Technical Note

MT9P012—Optimized Register Settings

Figure 1: Column Band In Image with R0x308A[6] = 1 (Default)

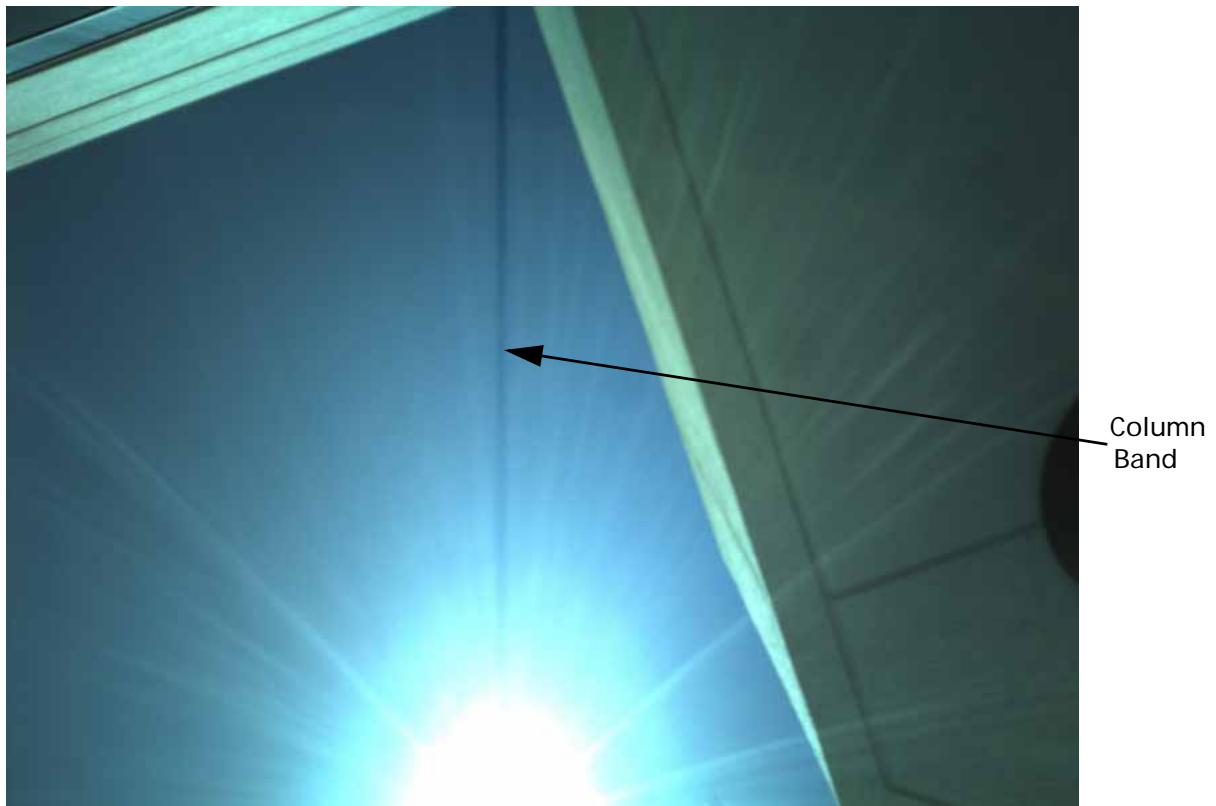
A dark band is occasionally seen across the height of the image when a bright light like the sun is directed to the bottom of the sensor array, as shown in Figure 1. This effect can be mitigated effectively by setting register bit field R0x308A[6] to 0x0000.
